Meeting Date: September 10, 2024

Planning and Zoning Board Meeting

B) SITE PLAN – PATEL FUEL & RETAIL: A REQUEST BY WALKER OWEN, P.E., OF CAUSSEAUX, HEWETT, & WALPOLE, LLC, APPLICANT, ON BEHALF OF SEMOJ 13, LLC, PROPERTY OWNER, FOR CONSIDERATION OF A SITE PLAN TO CONSTRUCT A ±8,836 SQUARE FOOT CONVENIENCE STORE, RETAIL BUILDING, AND GASOLINE FUELING STATION WITH ASSOCIATED SITE IMPROVEMENTS (QUASI-JUDICIAL HEARING).

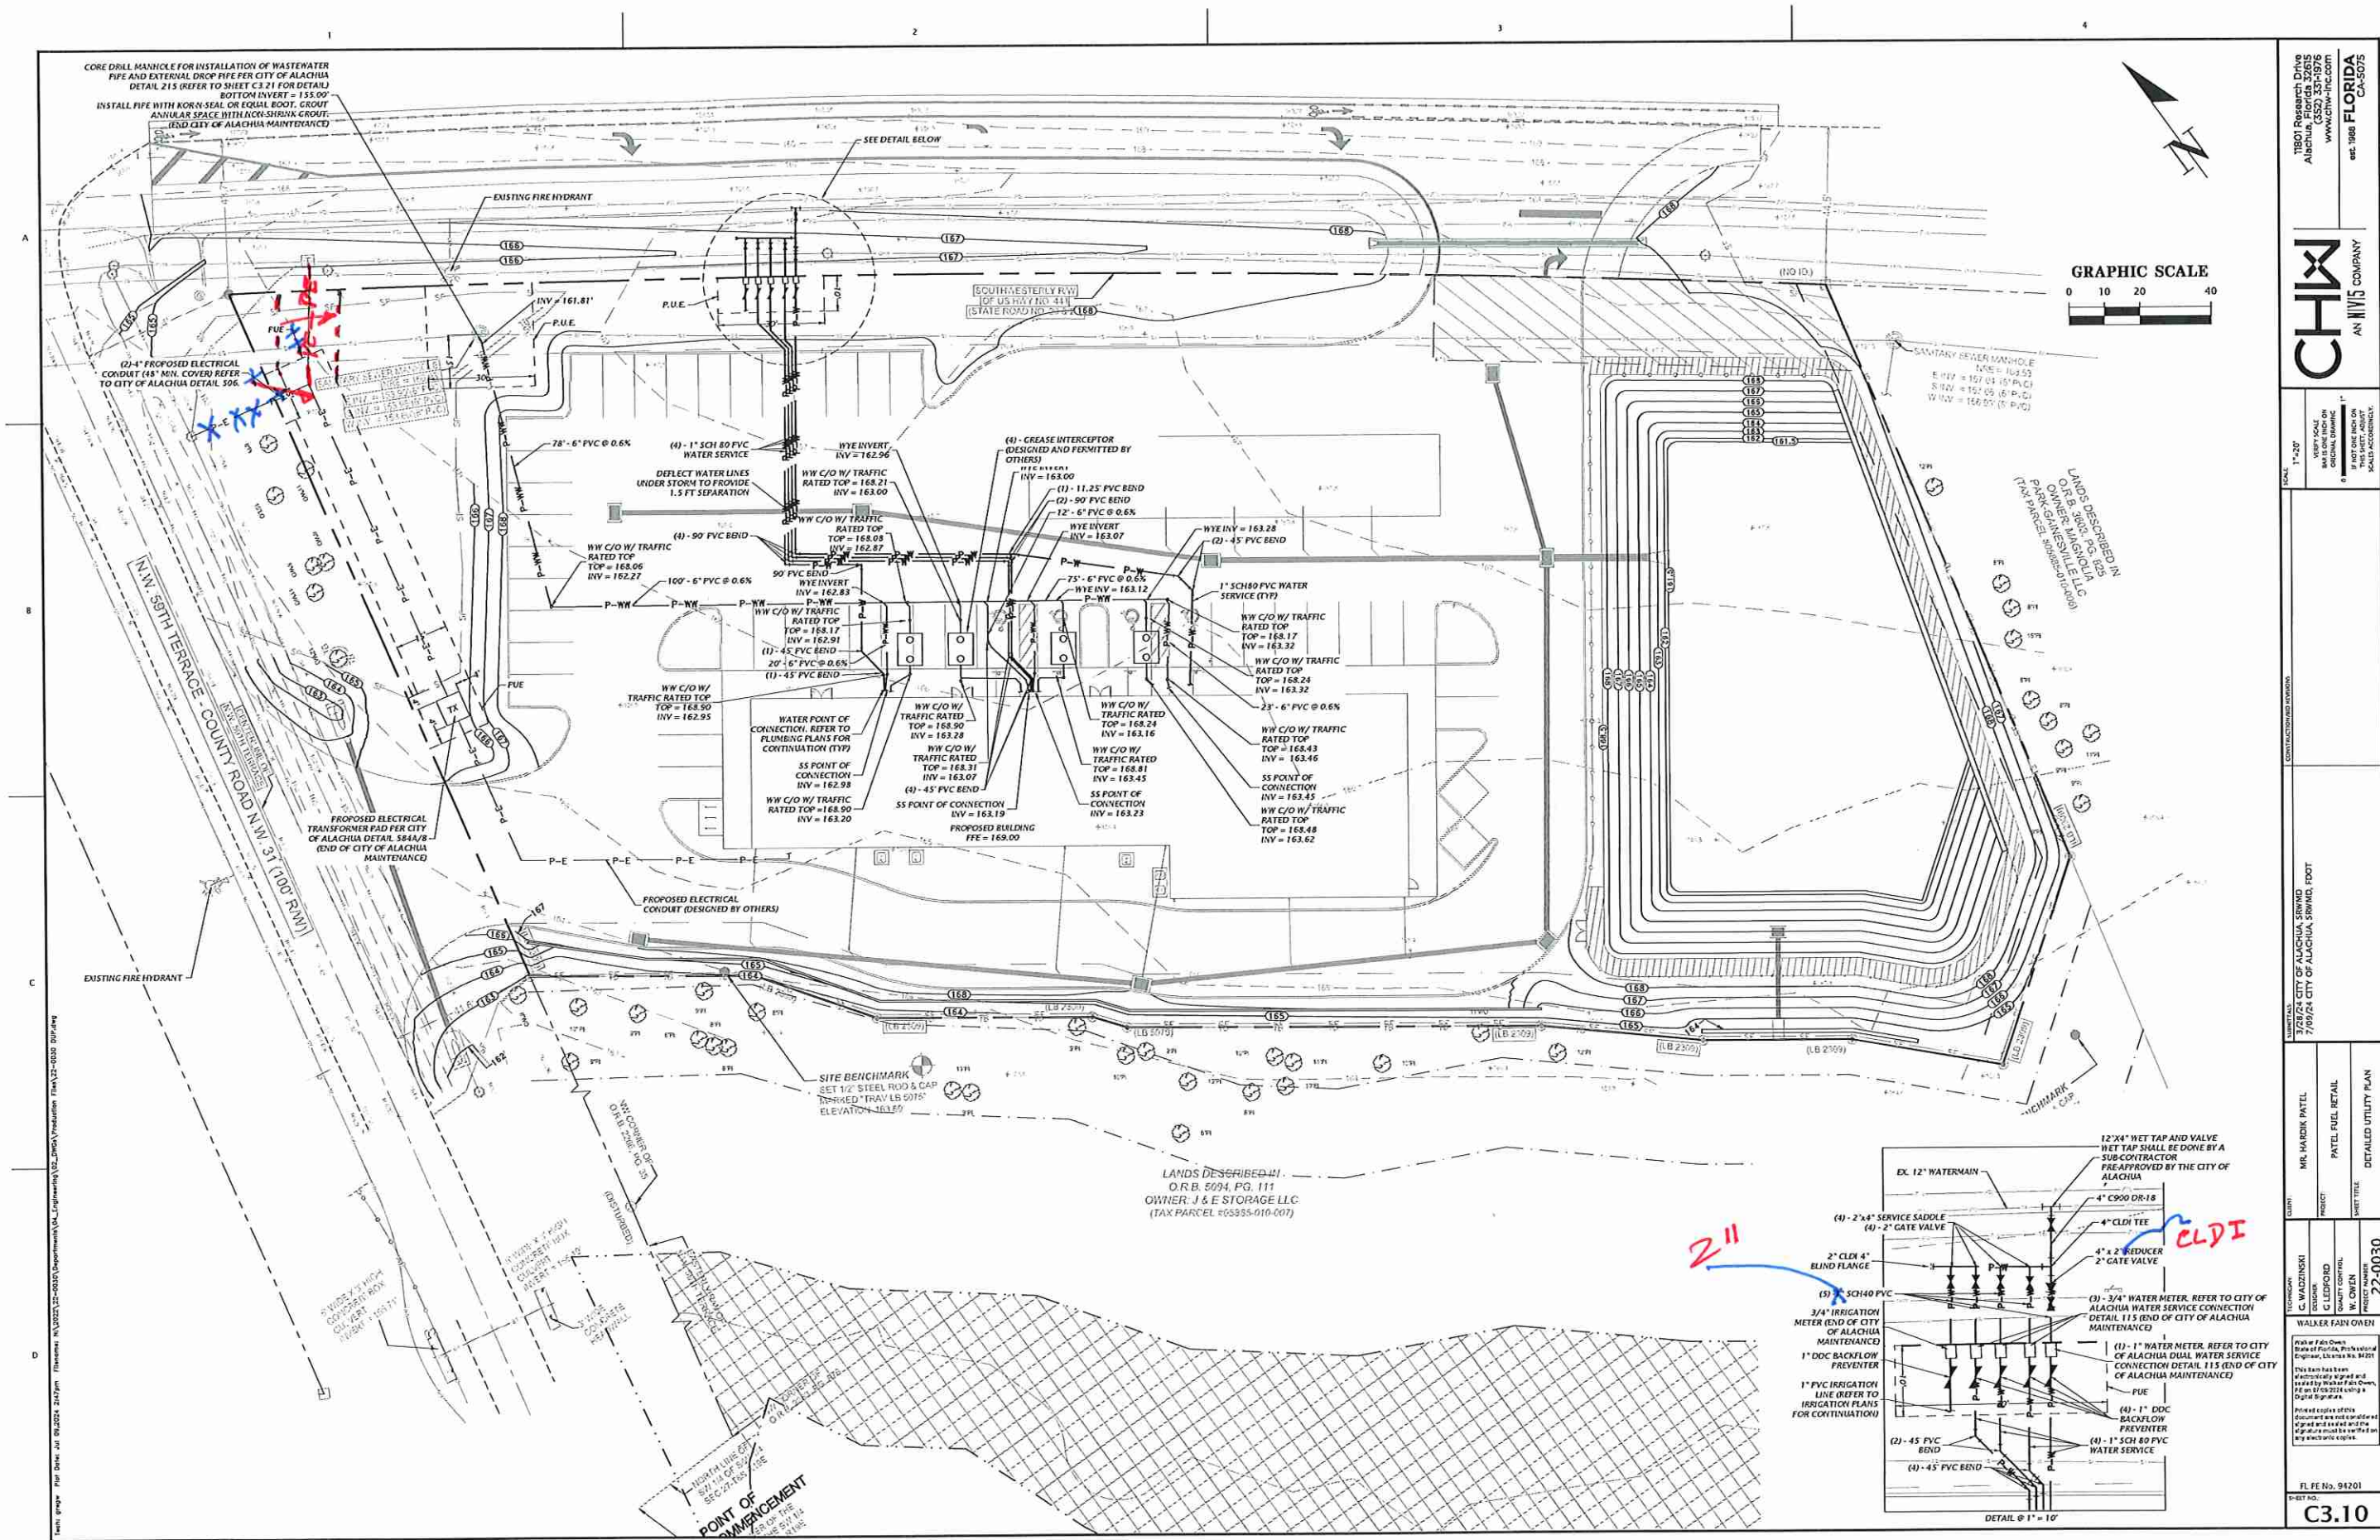
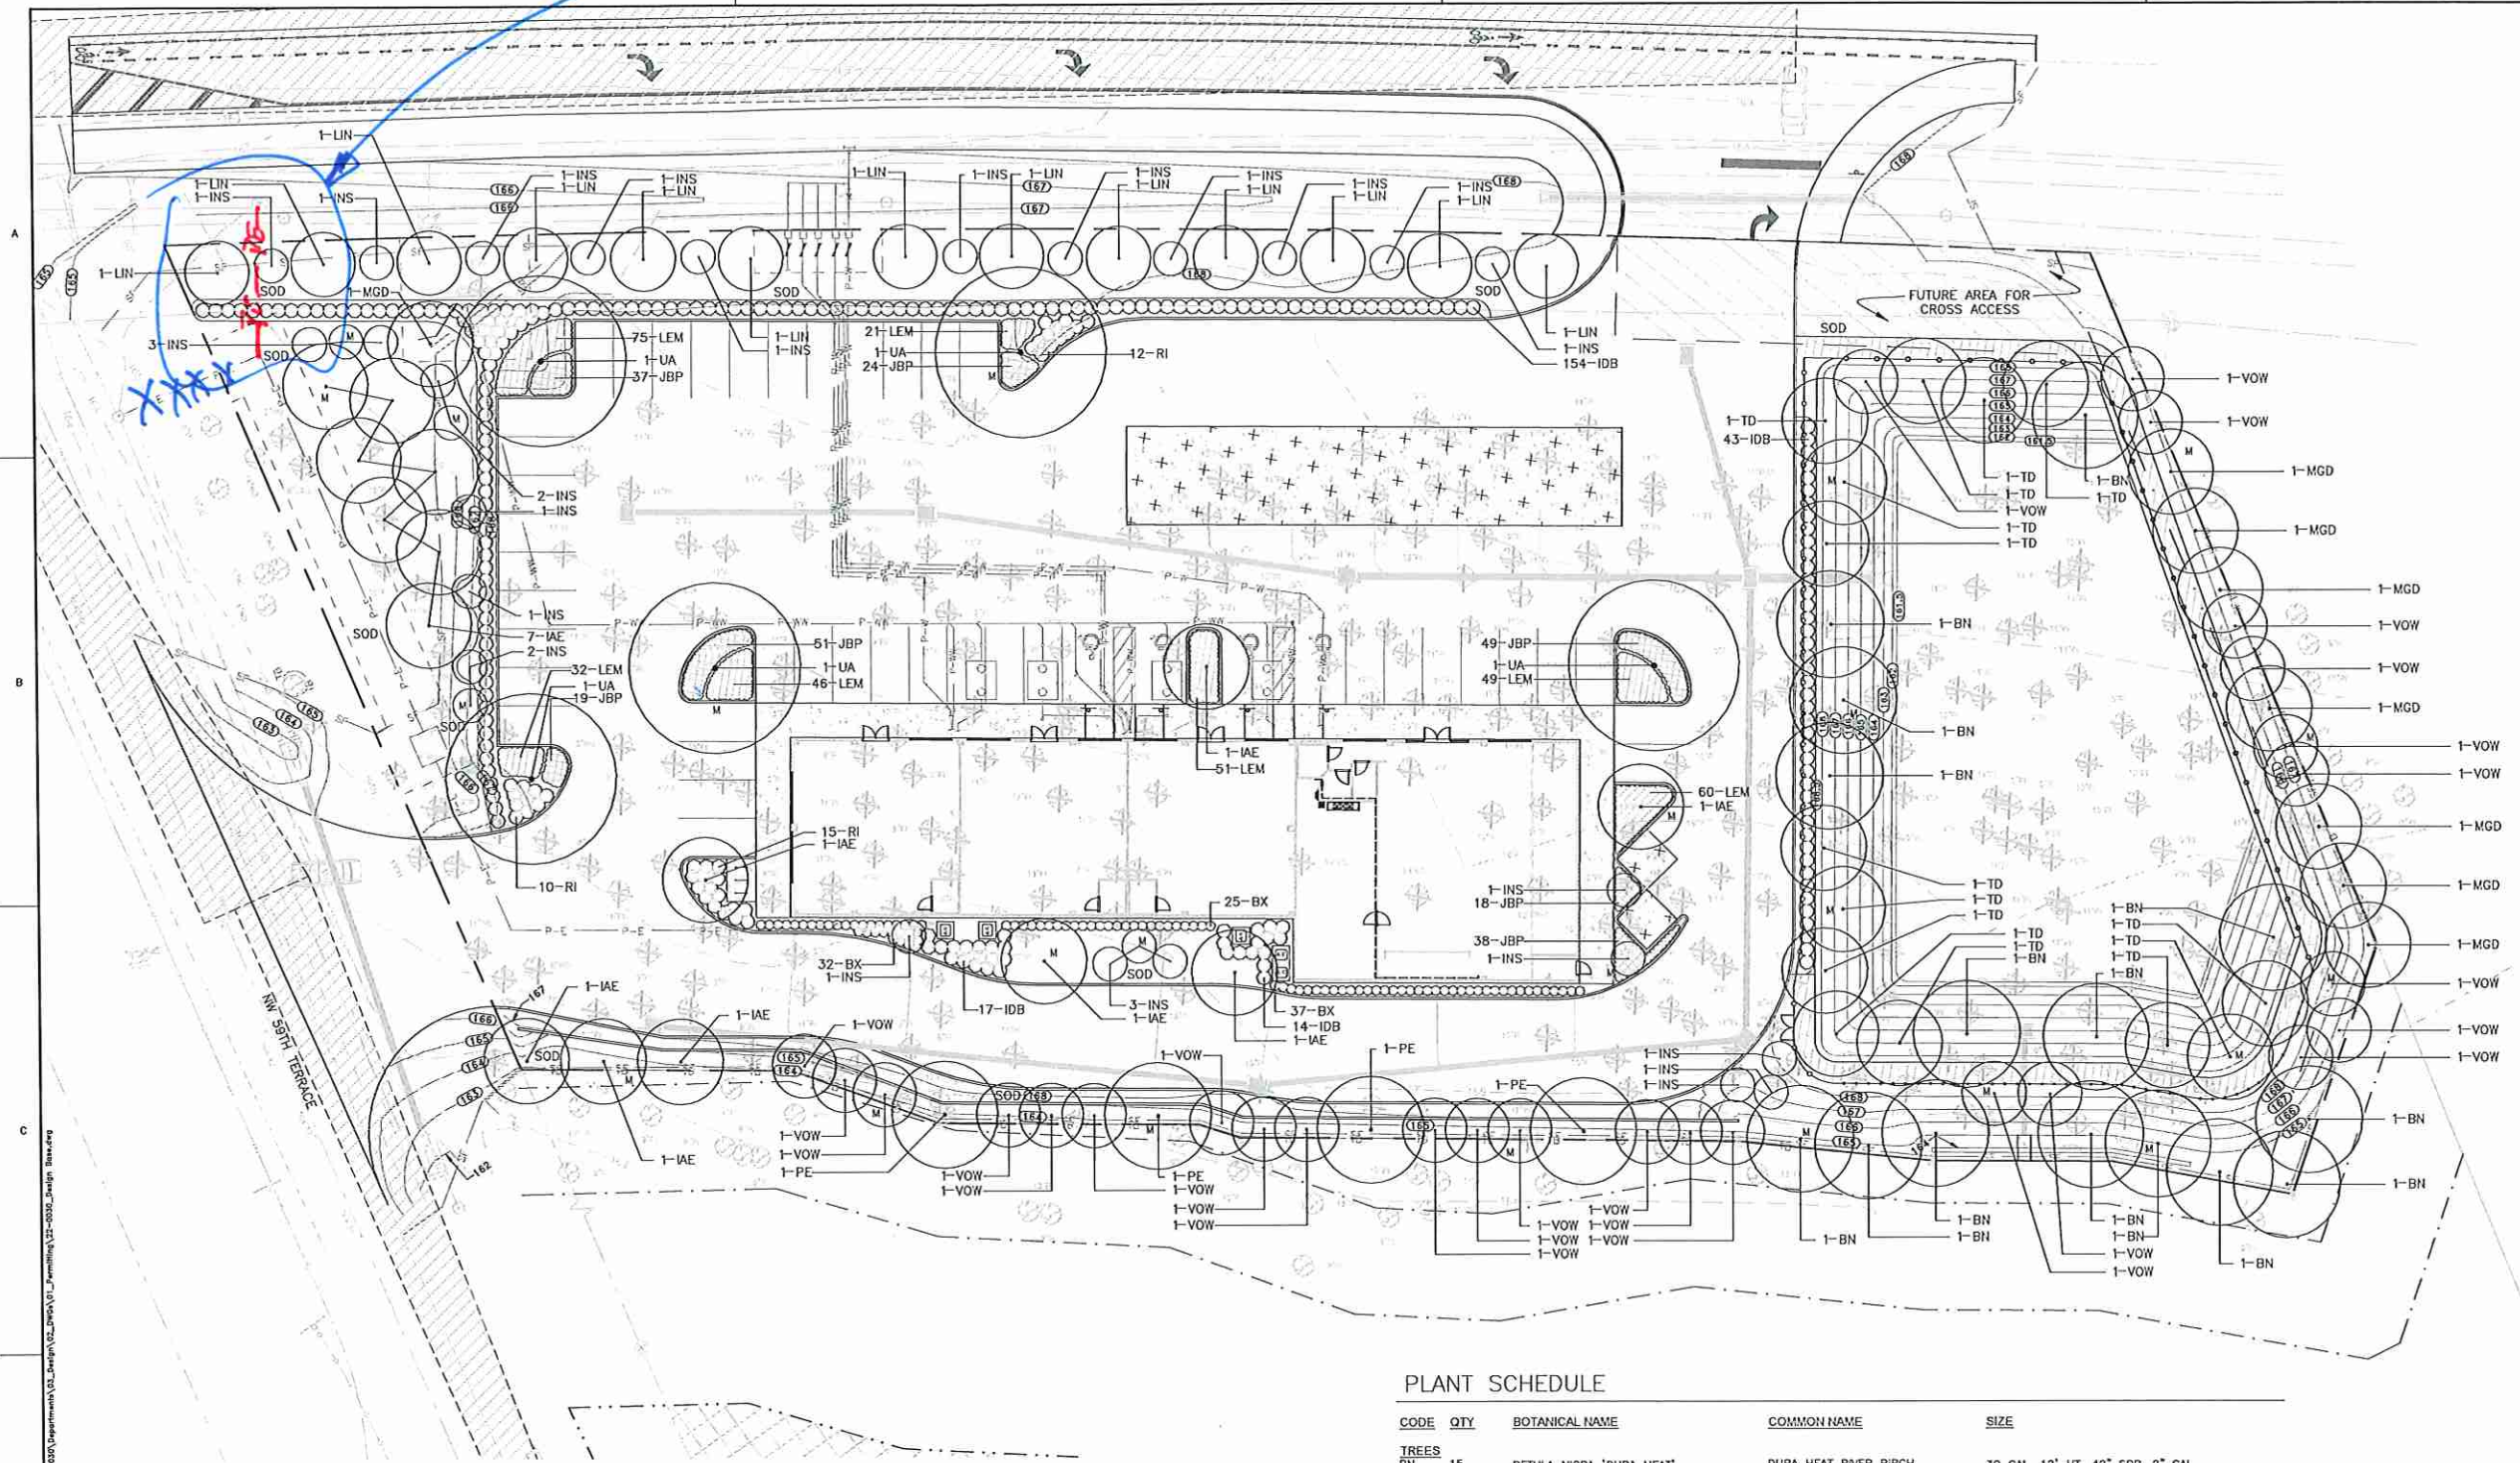
See markup. Coordinate with revised Sheet C3.10.

PLEASE EITHER REMOVE OR RELOCATE
TREES TO ALLOW ACCESS TO PRIMARY ELECTRICAL CIRCUIT

- The location of the tap of the proposed primary circuit has been updated. Please refer to Sheet C3.10. Please refer to Sheet C0.10 "Electric Service General Notes" #2-#9 for requested electrical specifications.

Objective 1.3: Commercial

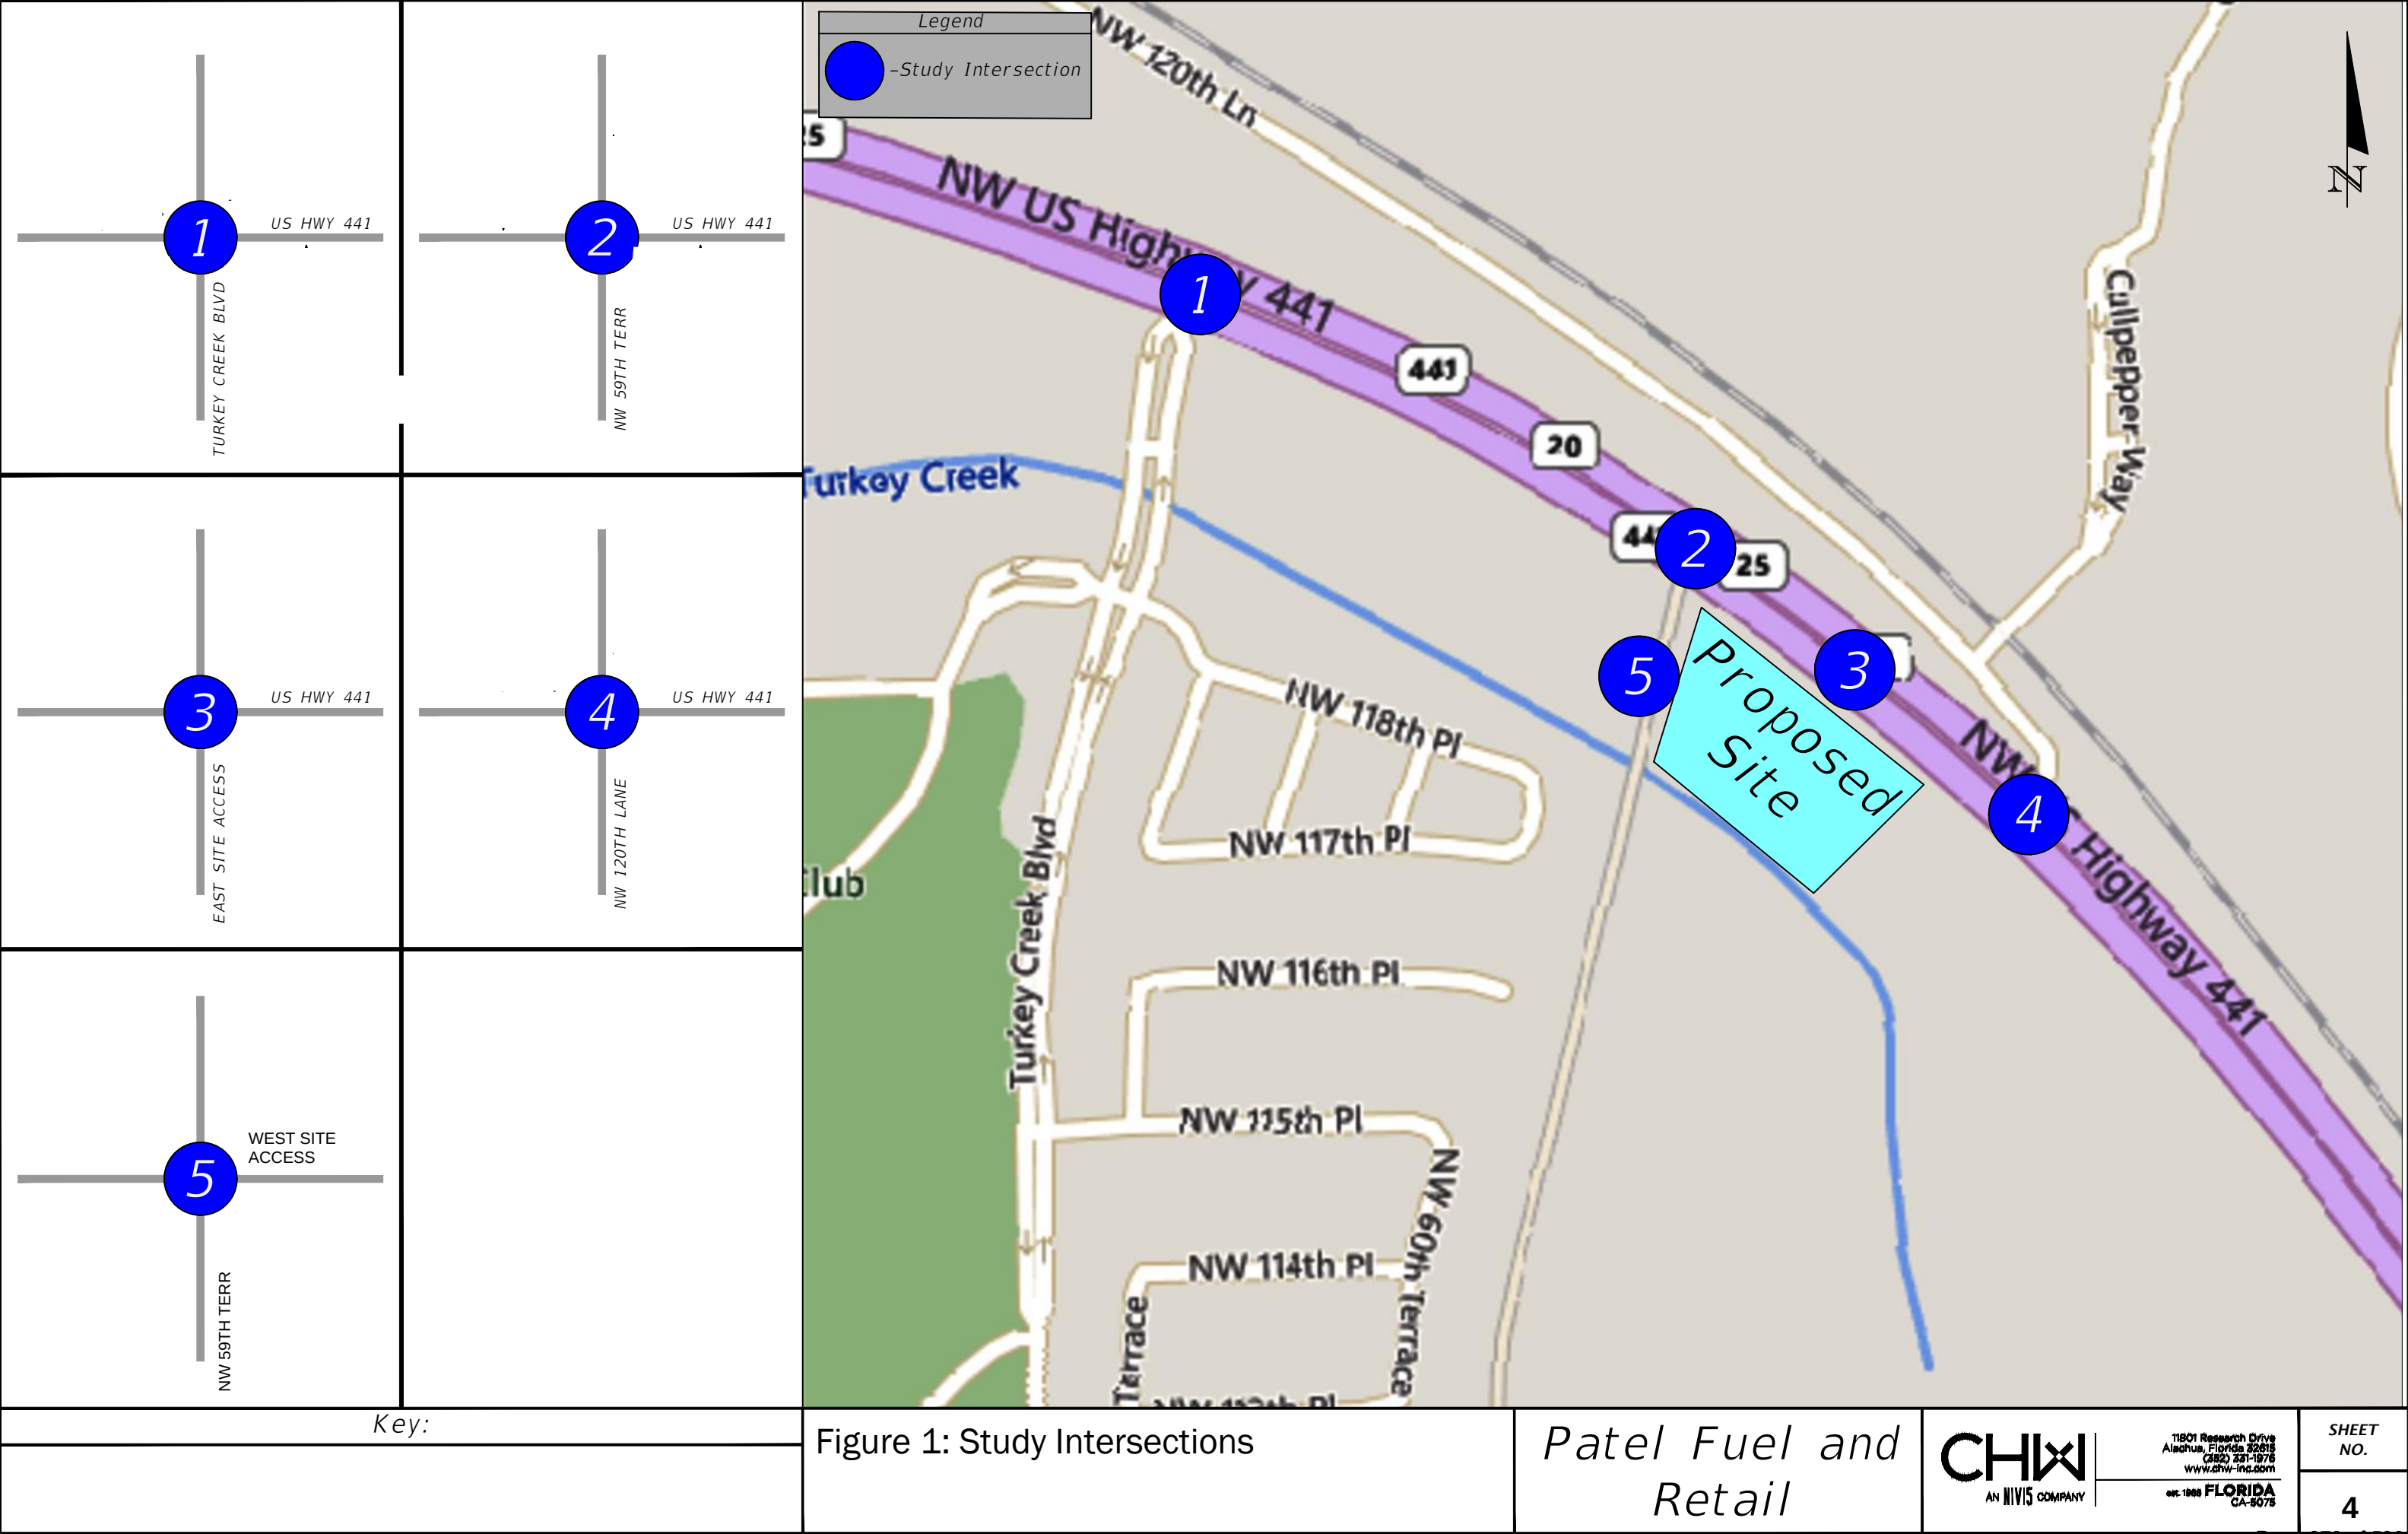
1. In Figure 1, Study Intersections, intersection #5 has an incorrect street name. The north/south street should be labeled NW 59th Terrace, not NW 25th Terrace.

1. In Figure 1, Study Intersections, intersection #5 has an incorrect street name. The north/south street should be labeled NW 59th Terrace, not NW 25th Terrace.
Response: The street name in Figure 1 has been corrected as requested.
